PL2021-116
PL202100116

SHELLING HALL

WELCOME CENTER/ COFFEE SHOP
2480 SF ADDITION

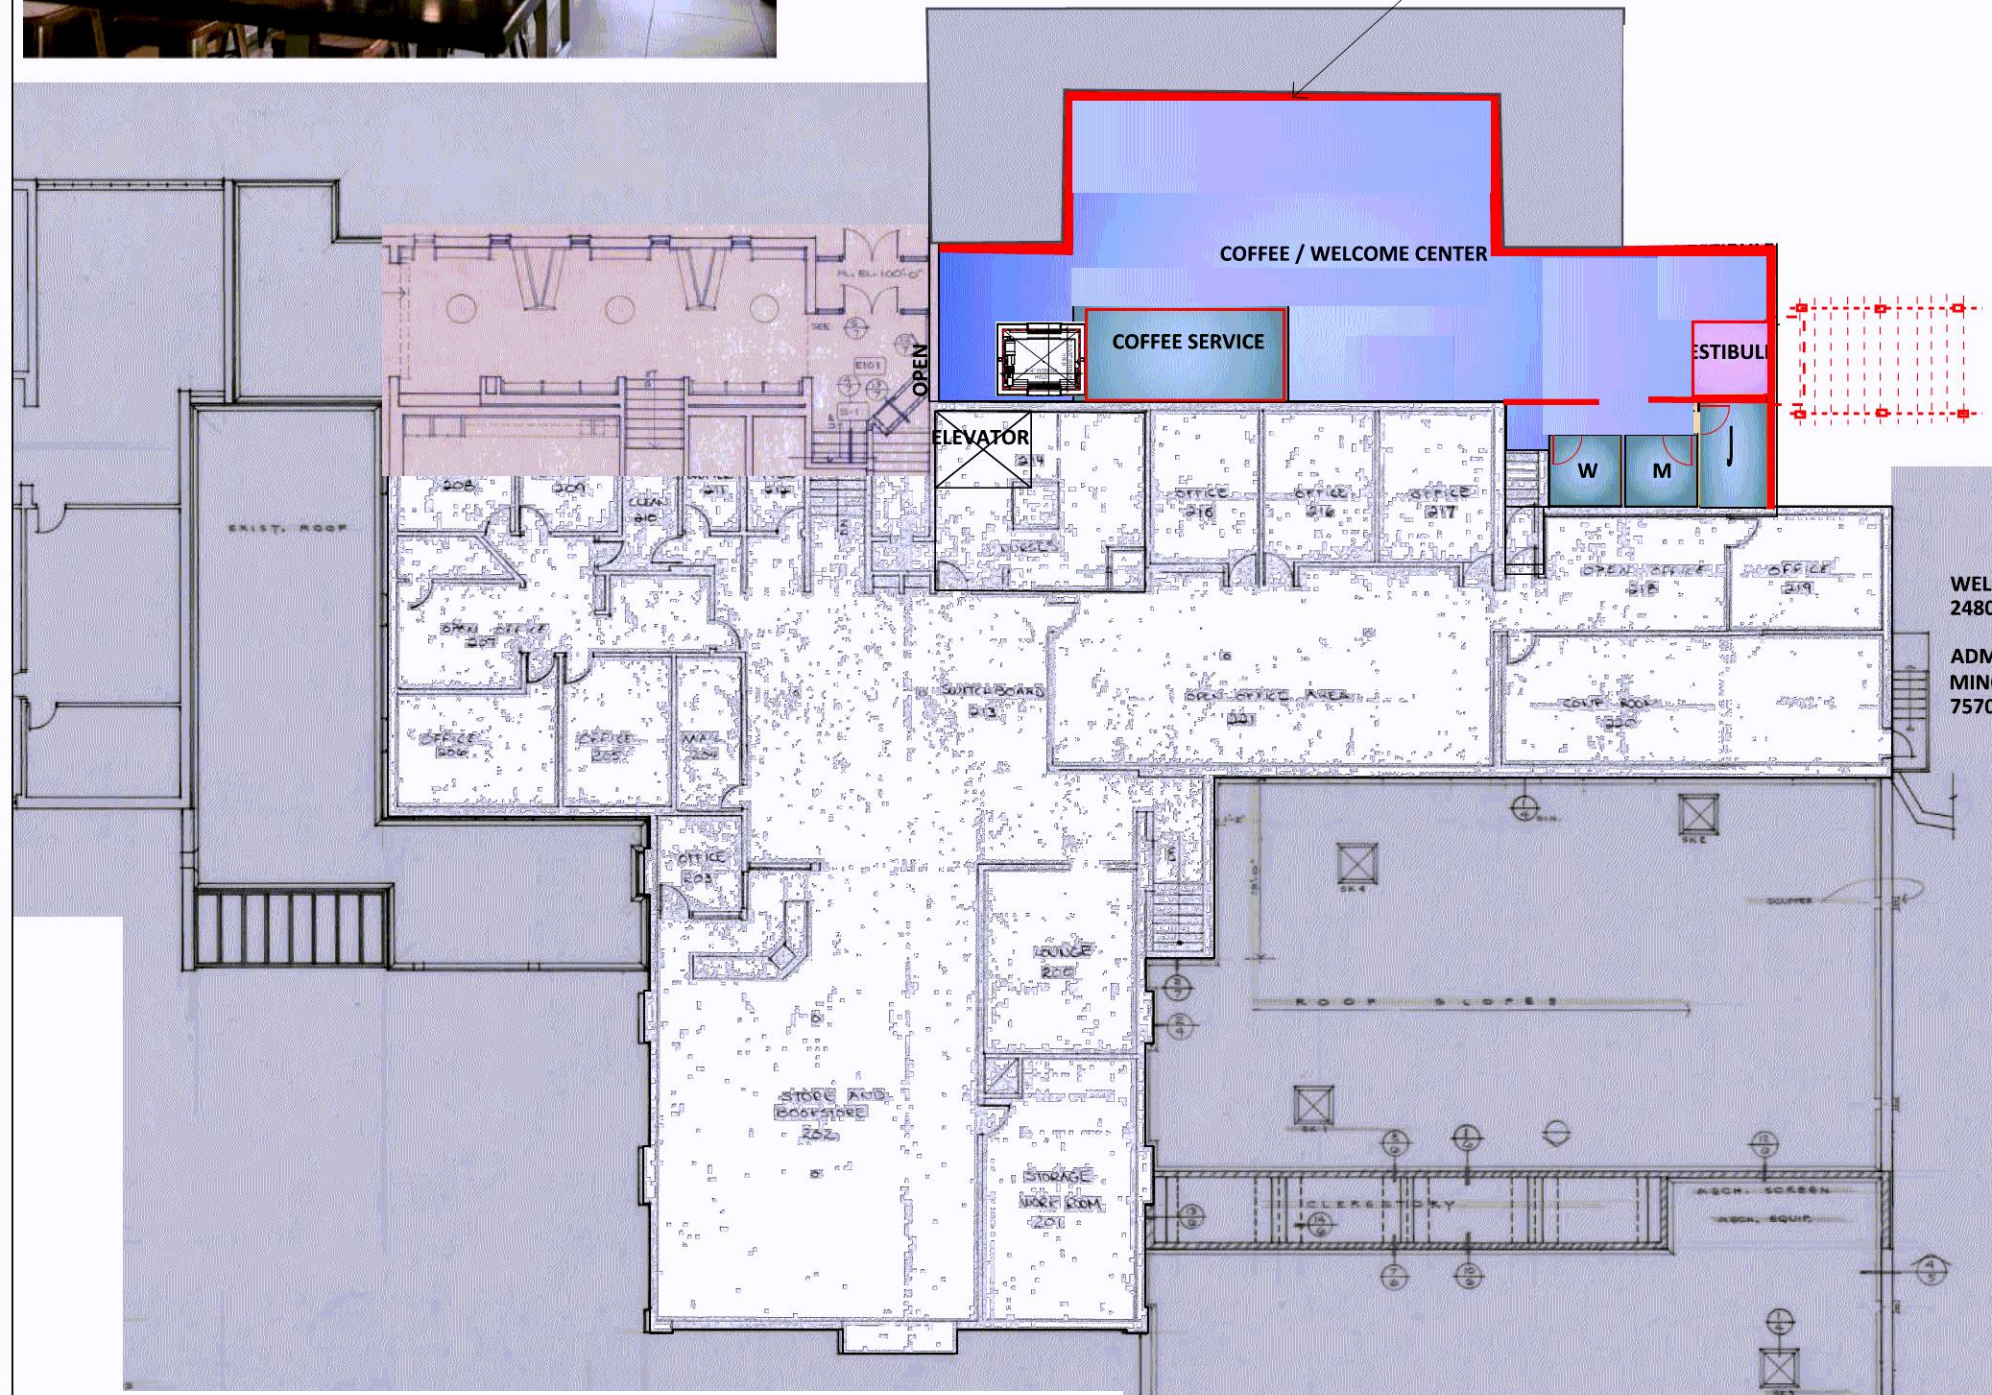
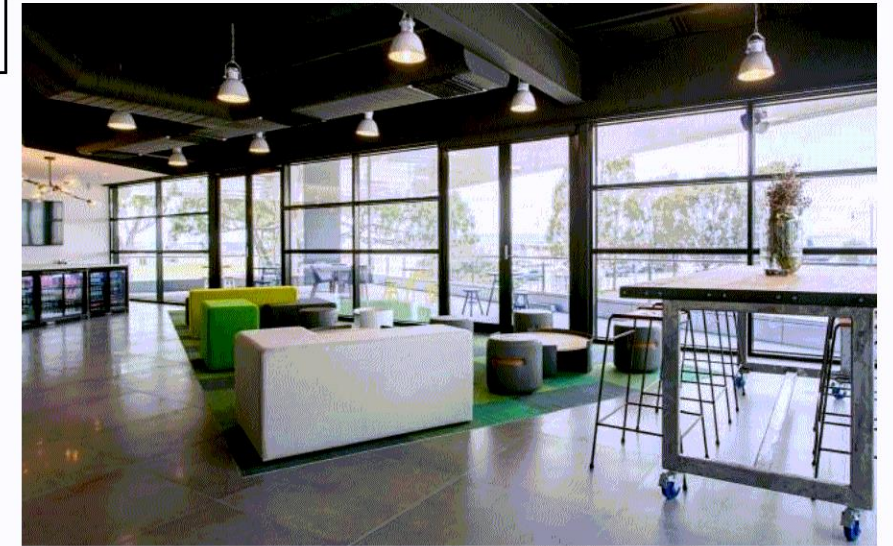
Show where this is in context of parking spaces, sidewalks, other driveways, etc.

Must meet 2020 MN State Building Code

Must meet 2020 MN Accessibility Code.

Building plans must be signed by a MN licensed architect.

SAC review by MET council will be required.

Provide a detailed code analysis with the plans.

Separate permit and review by MN State Elevator inspector for elevators, escalators and moving walkways.

Per Chapter 1306, the building and new addition is required to be sprinklered.

Fire alarm may need to be upgraded based on the occupancy type.

Emergency vehicle access shall be provided/maintained.

Additional hydrant coverage may be required.
